REPORT NUMBER: 76/20

APPEAL ITEM - 110/00668/19 - 29 PATAWALONGA FRONTAGE,

**GLENELG NORTH**

### 2. Compromise proposal

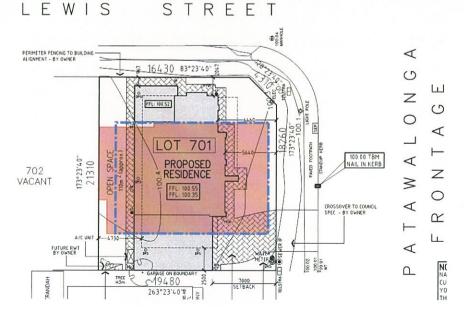
In considering the position and setbacks of the building (particularly relative to the Patawalonga boundary), it is important to recognise that the applicant could orientate the building to face Lewis Street, and therefore completely obliterate the north-easterly view enjoyed by the southern adjacent neighbour, which is the primary concern raised during the category 2 public notification process. The plan below illustrates the kind of building positioning that could be achieved, as of right, via the residential code:

The plan shows a substantial building envelope could be achieved under the code, which would sit only 900mm from the Patawalonga street boundary and upper level as close as 1.9 metres from the western boundary. The blue dotted line depicts the envelope of the upper level. Note: the code building envelope is larger than that currently proposed.

## **ATTACHMENT A.0**

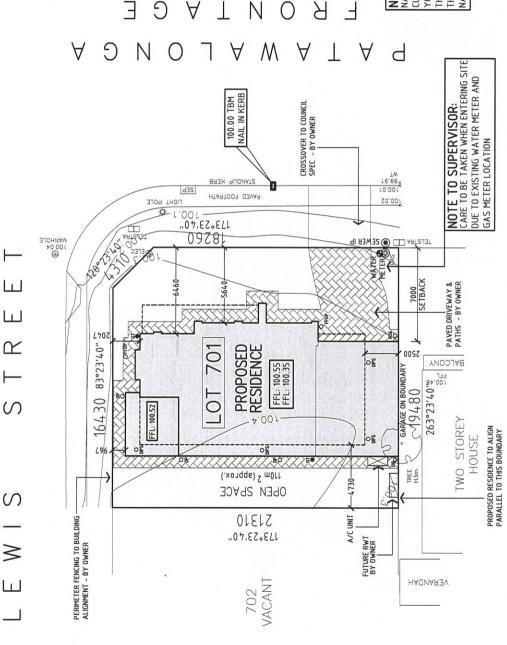
The building has been altered to achieve increased primary street boundary setbacks, including:

- The garage is now setback 7 metres in lieu of 6.17 metres;
- The dwelling is now setback 5.6 metres adjacent to the garage in lieu of 5 metres;
- The dwelling is now setback 6.4 metres adjacent to the corner of the site in lieu of 4.3 metres;
- The closest point of the dwelling remains at 4.3 metres, however this comprises a smaller portion of the building wall
